TIMCO ENGINEERING INC.849 NW State Road 45
Newberry, Florida 32669

Subject : Correspondence of your question. Job # 2590KC5
FCC ID: BEJL1770HN

Main Board Block Diagram (Before)

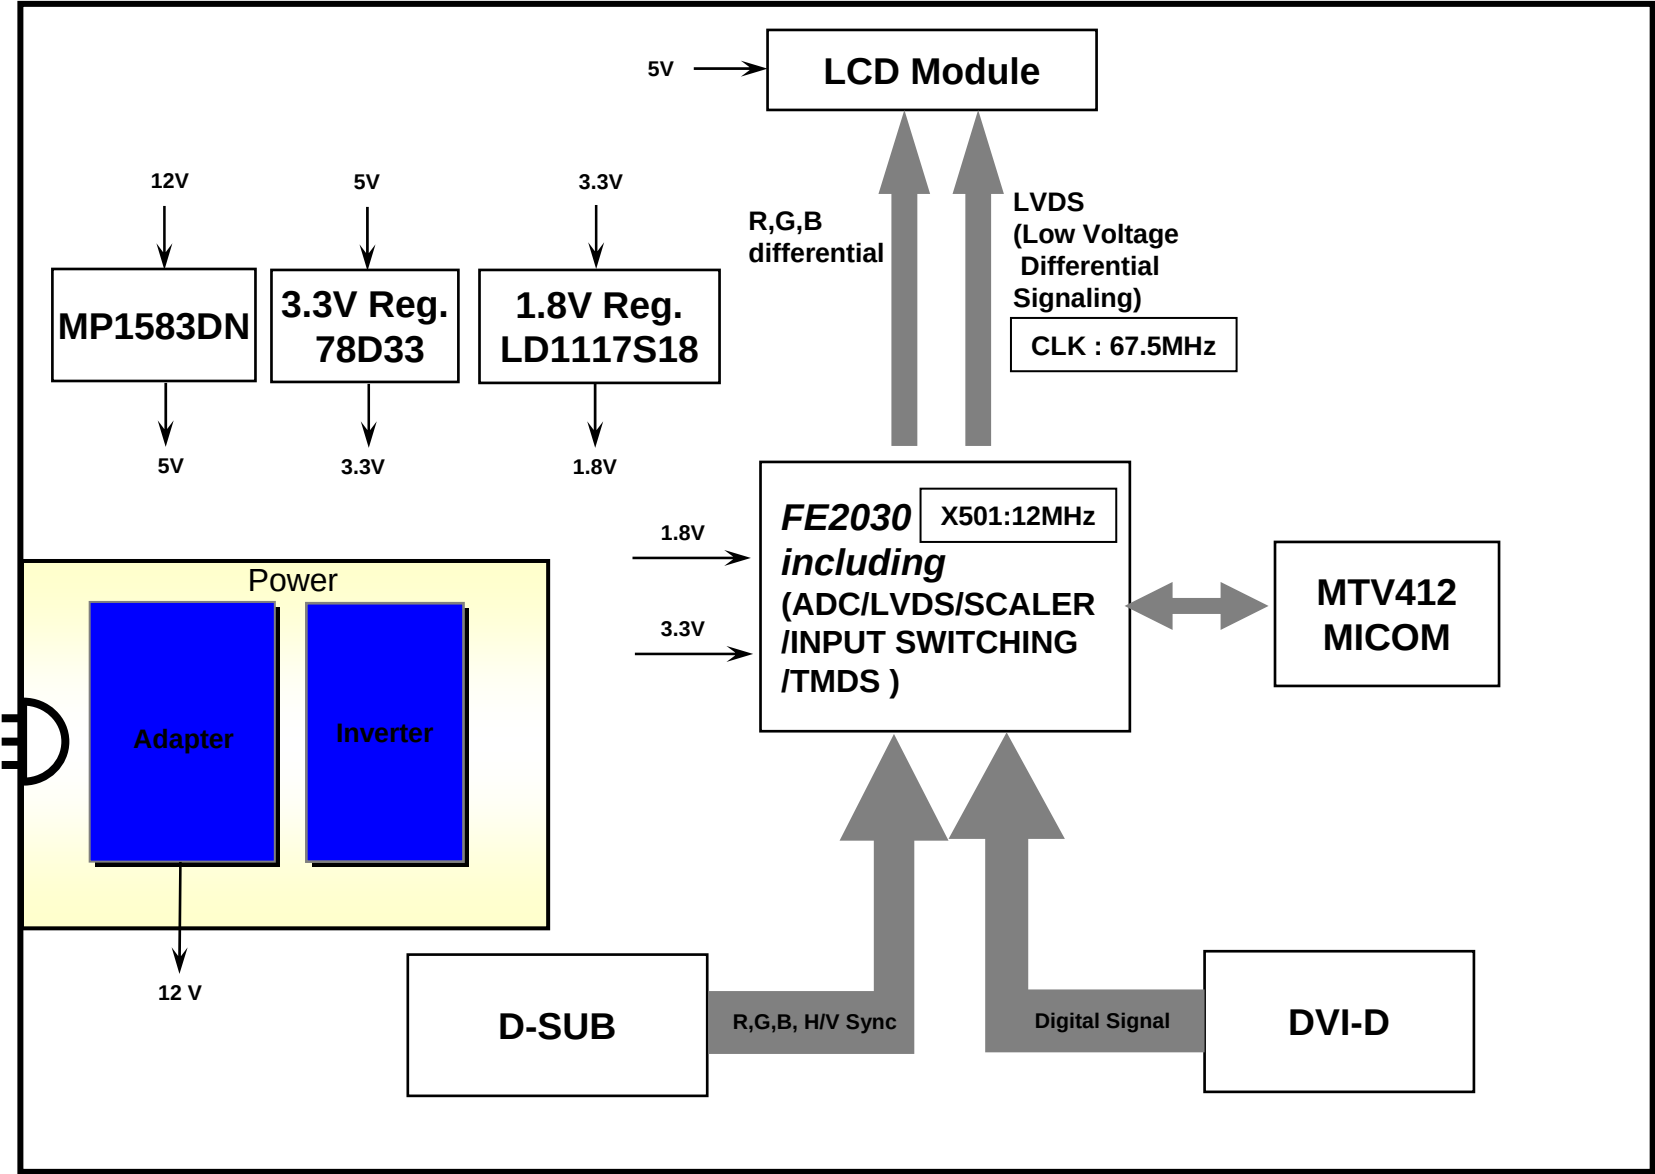
- The purpose of change is upgrading the picture performance. The response time of LCD picture is from 8ms to 4ms. The below parts are added or changed to make upgrading the visual performance.
 - Changed Scaler IC : TSU56AWL
 - Added SDRAM 16M
 - Added ODC(overdrive circuit) IC: NVI S5001
- ➔ The main function (i.e. Resolution timing table, Data clock frequency, VCC Power) is exactly same with originals. Therefore, I believe it can comply with FCC regulation Part 2.1043 and to be treated Class II permissive change.
